# Rezoning Transportation Analysis

Petition Number: 2018-126

Date	Description
11-16-2018	First Review (IW)
12-20-2018	Second Review (IW)
04-24-2019	Third Review (IW)

## ~~Yorkmont Road and Oak Lake Boulevard~~

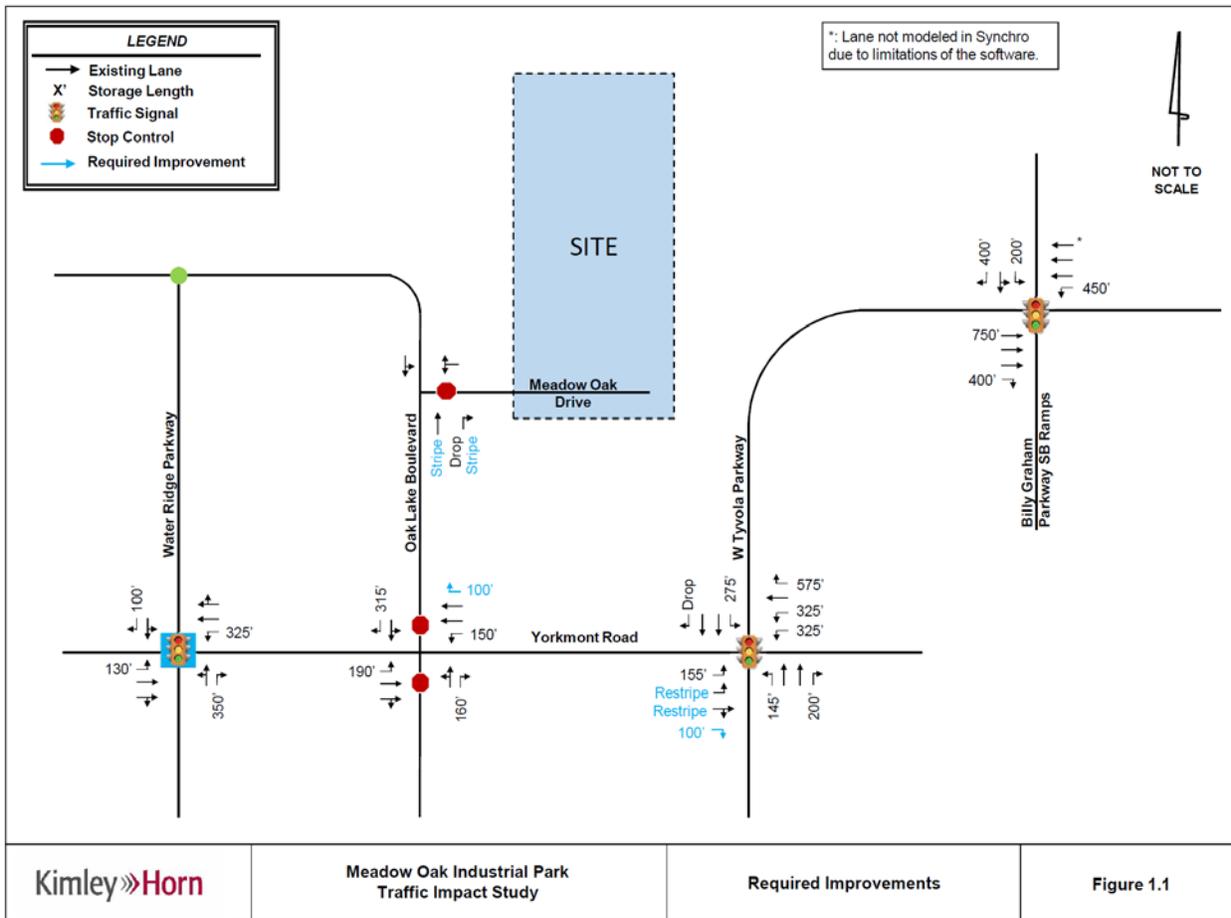
- Construct a westbound right turn lane along Yorkmont Road with 100' of storage.

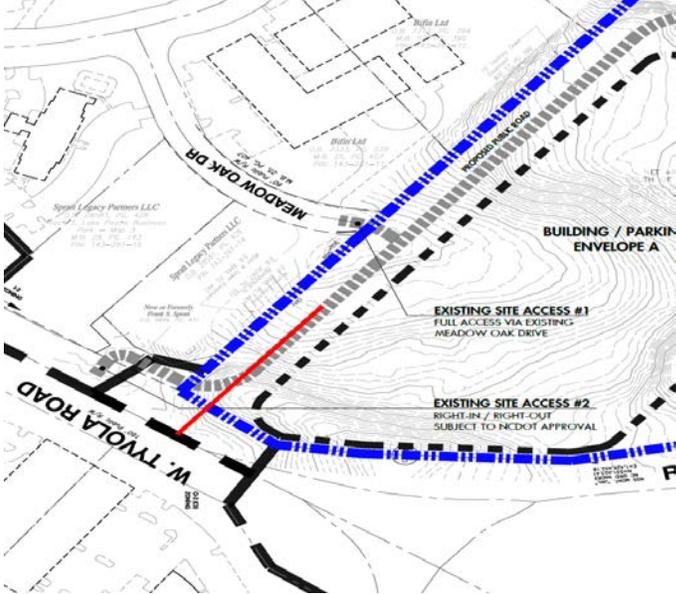
- The petitioner shall revise the site plan and conditional note(s) to construct planting strip and sidewalk per the Westside Strategic Area Plan, to show the 8' planting strip and 12' Multi Use Path (MUP) in conjunction with curb and gutter along Tyvola Road. **Technical Correction:** Add conditional note stating that the petitioner is committing to construct the planting strip, sidewalk, and curb and gutter.
- The petitioner should revise the site plan and conditional note(s) to realign access to West Tyvola Road.

- The petitioner shall revise the site plan and conditional note(s) to realign the Billy Graham free flow right turn ramp to the signal on West Tyvola Road to provide adequate spacing between the proposed driveway and right turn movements from the ramp. The ramp needs to be analyzed to determine the length of the dual right turn lanes needed at the ramp, when it is realigned. The site plan shall show the updated lane configuration at this intersection. **Additional Information:** After updating site plan to show realignment of ramp, petitioner shall update site plan to show extension of 8' planting strip and 12' MUP to new intersection, and curb and gutter along Tyvola Road. **Comment Rescinded**
